January 25, 2001

SUBJECT: SAFETY EVALUATION REPORT ON EPRI TOPICAL REPORT NP-7450(P),  
REVISION 4, "RETRAN-3D - A PROGRAM FOR TRANSIENT THERMAL-  
HYDRAULIC ANALYSIS OF COMPLEX FLUID FLOW SYSTEMS" (TAC NO.  
MA4311)

SAFETY EVALUATION BY THE OFFICE OF NUCLEAR REACTOR REGULATION  
RELATED TO EPRI NP-7450(P), "RETRAN-3D - A PROGRAM FOR TRANSIENT  
THERMAL-HYDRAULIC ANALYSIS OF COMPLEX FLUID FLOW SYSTEMS"

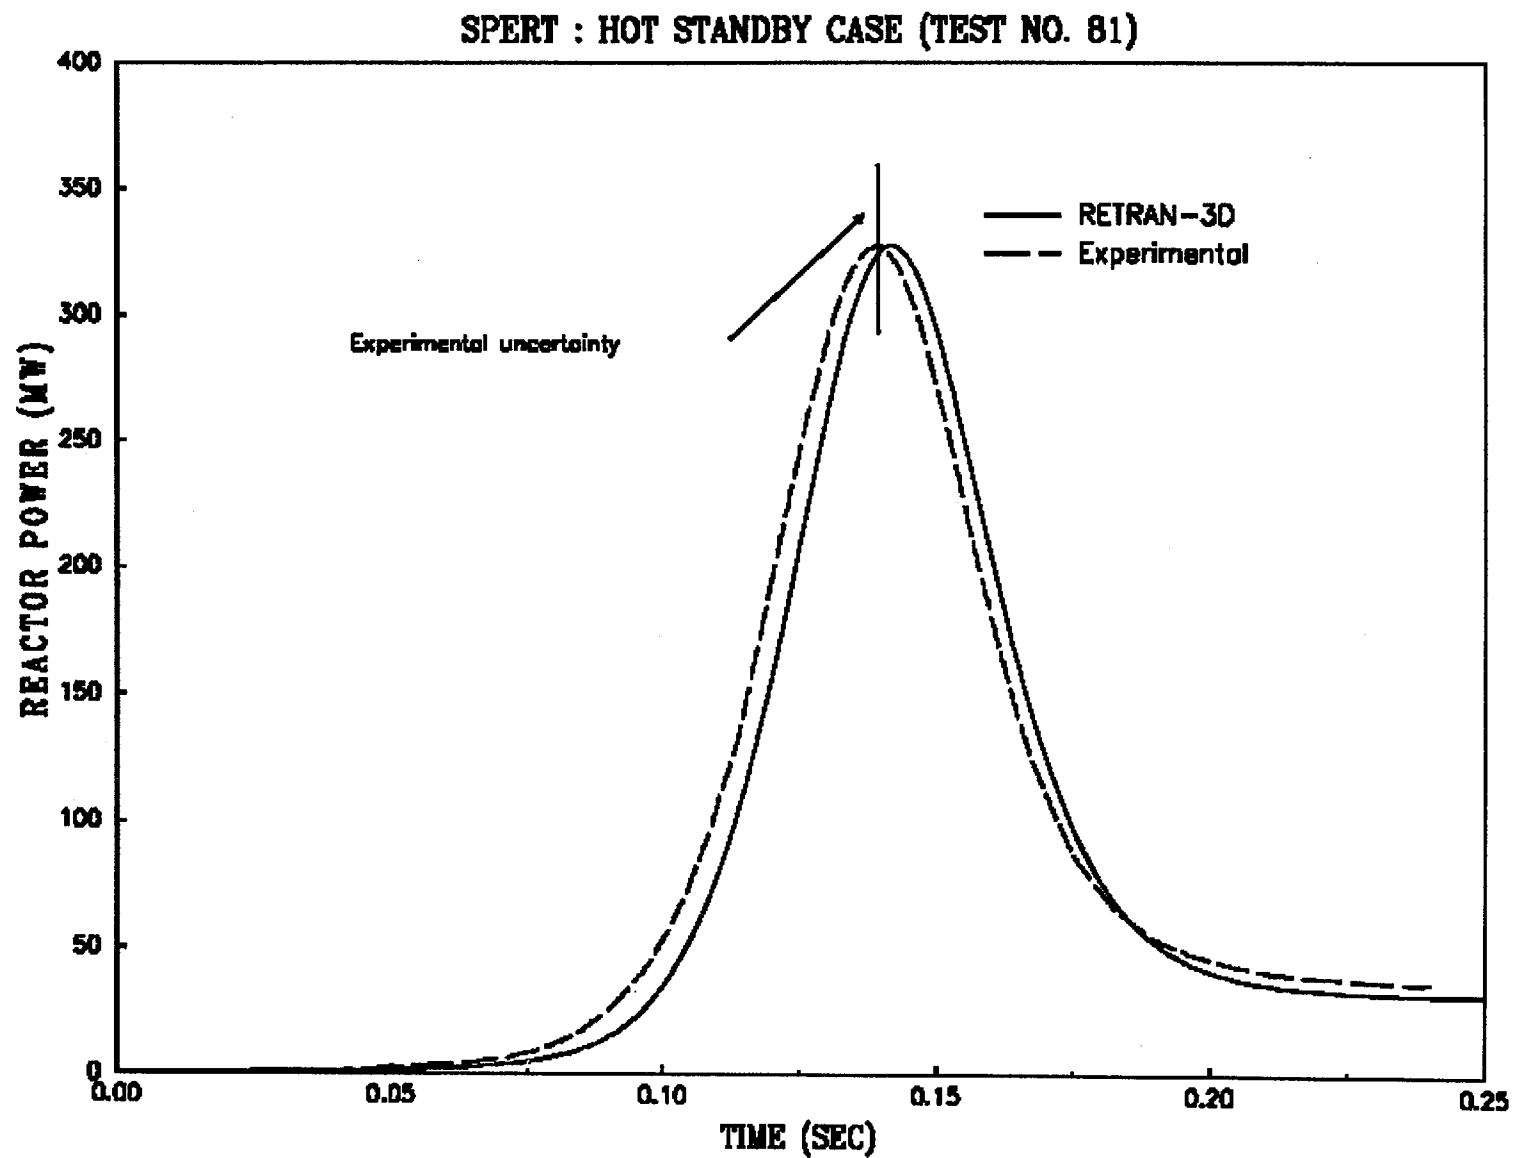
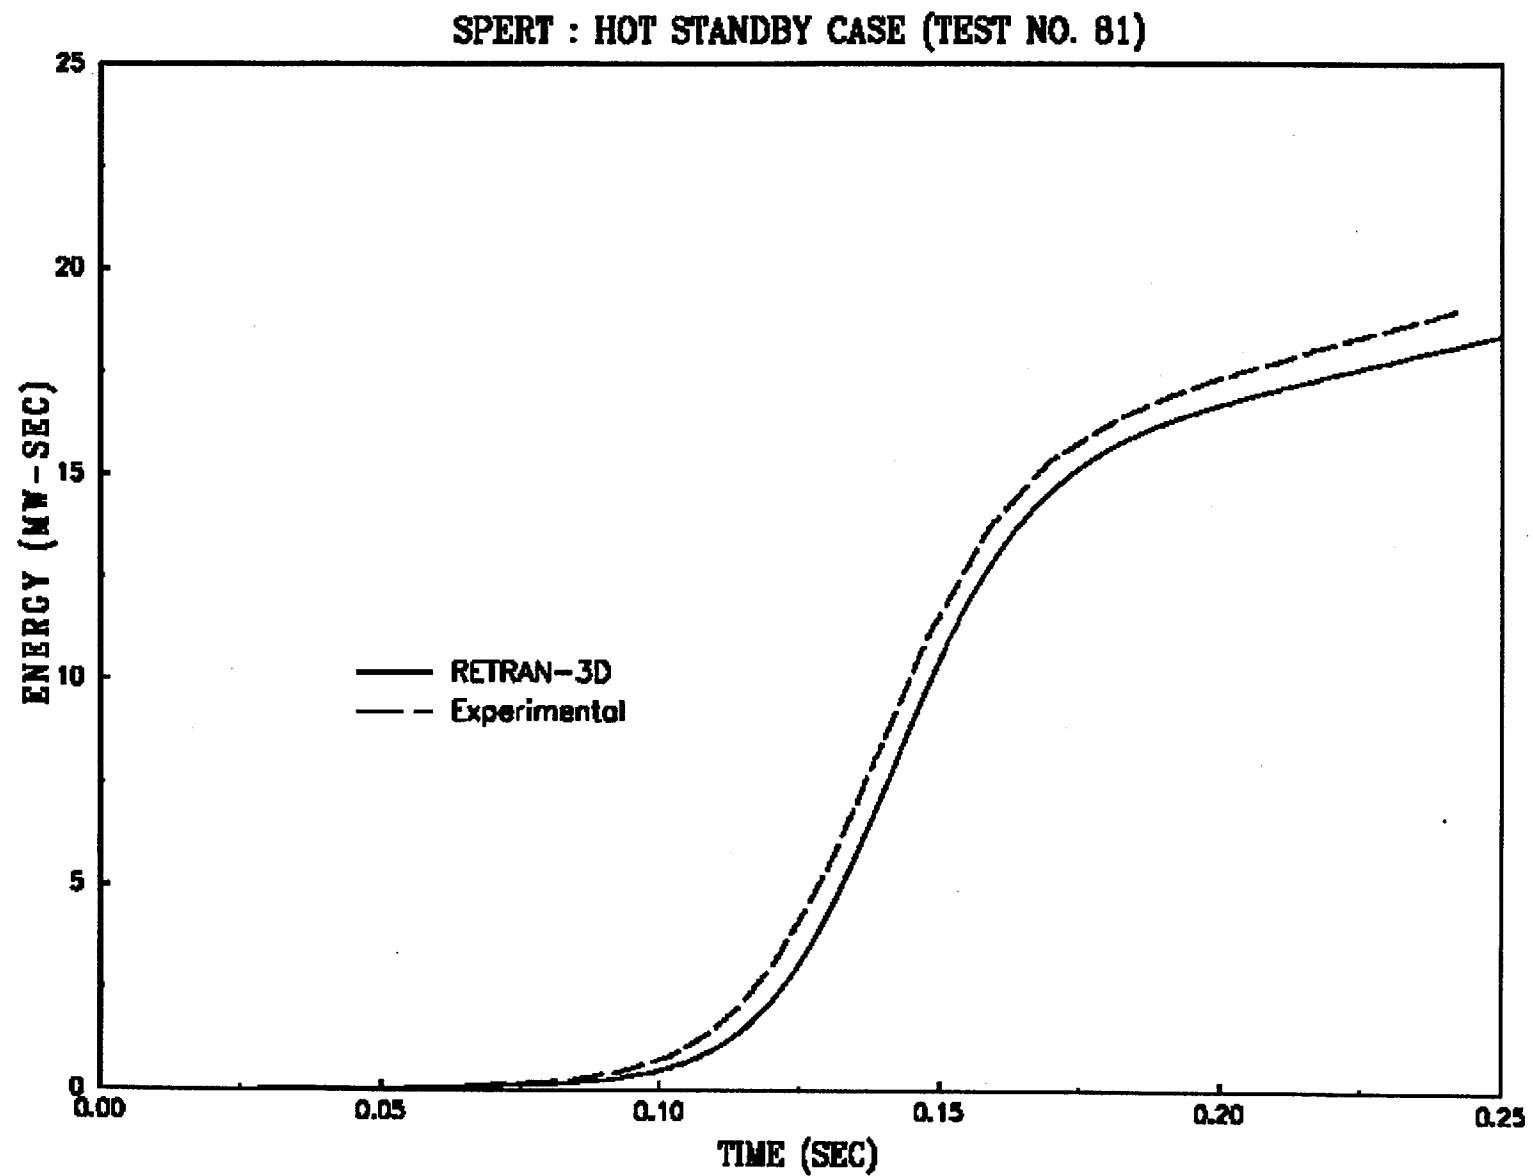
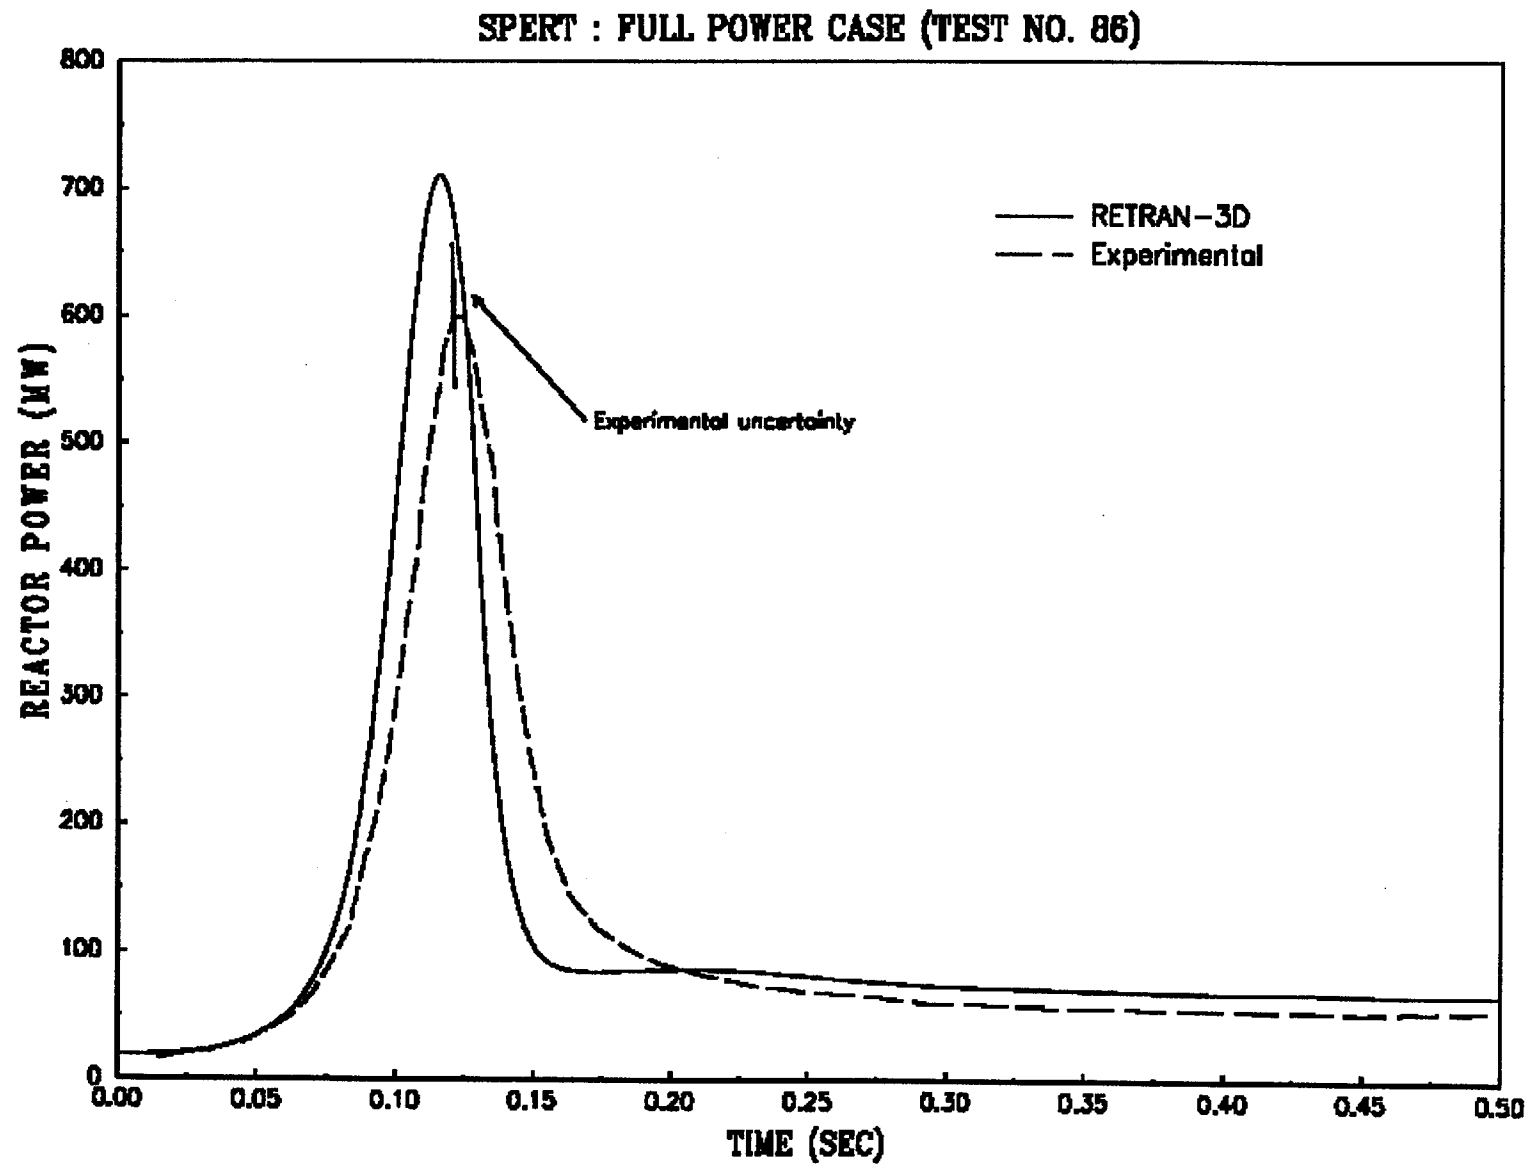
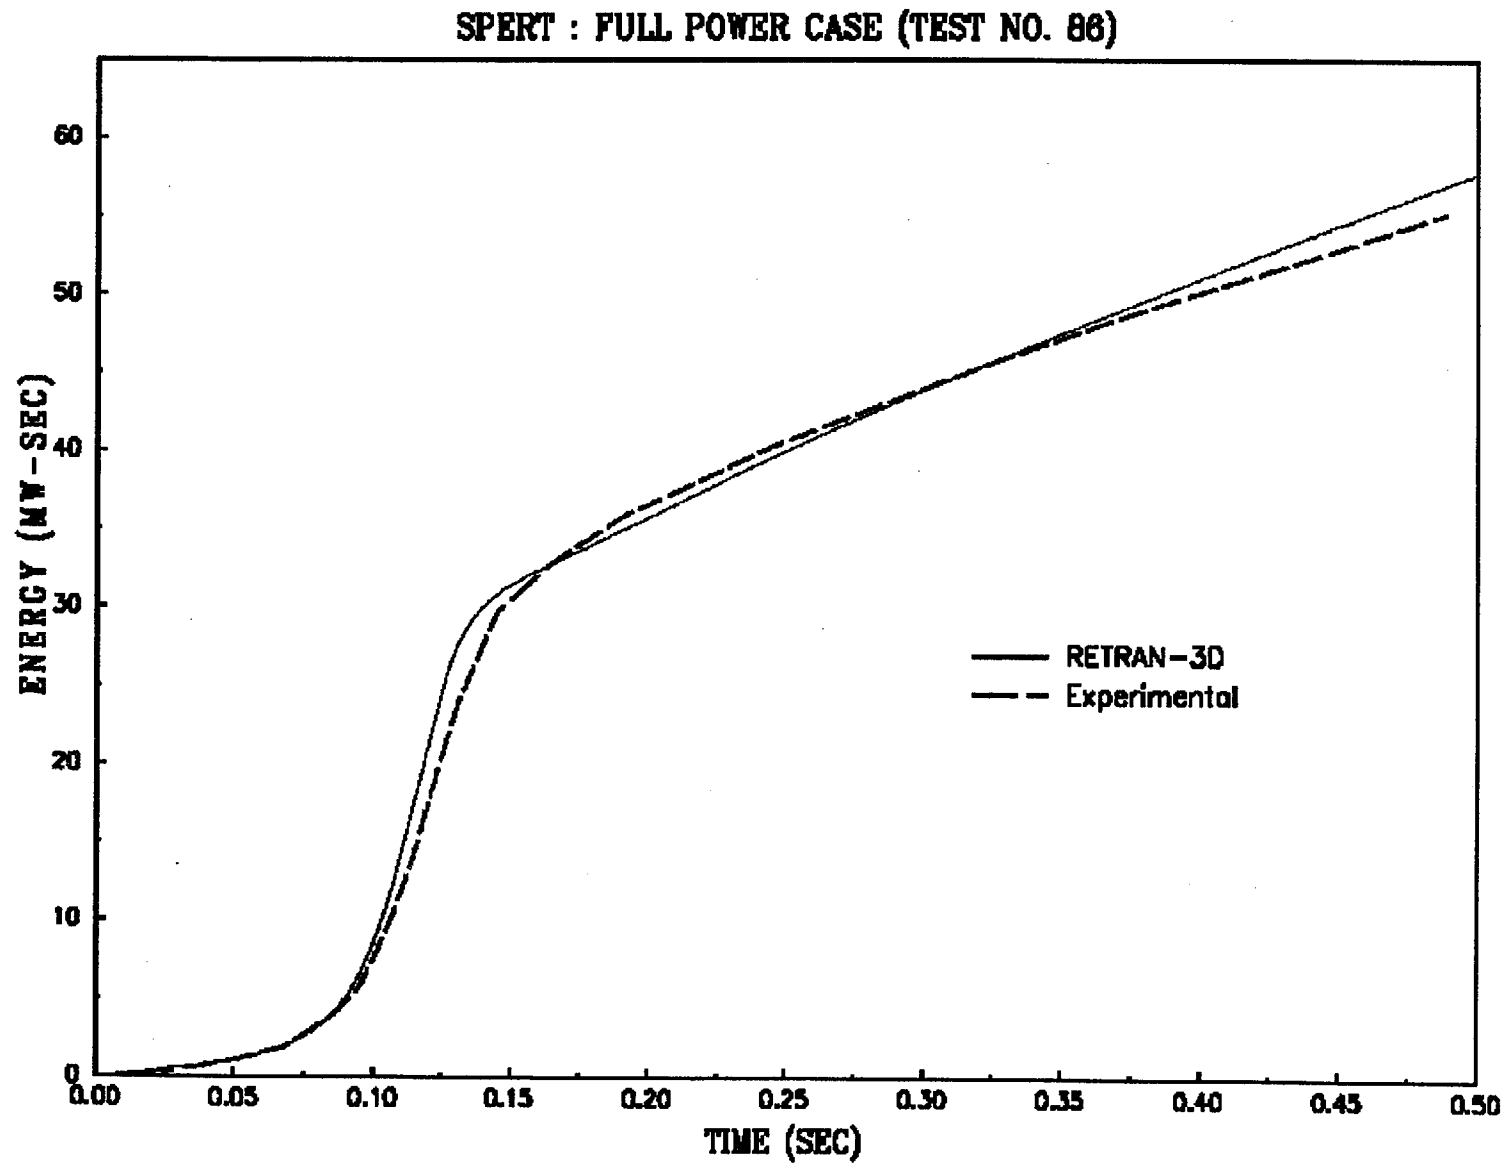
information were provided to EPRI to assist their prediction of the SPERT tests with RETRAN-3D. Figures 3 through 6 show that RETRAN-3D also accurately predicted the test results.
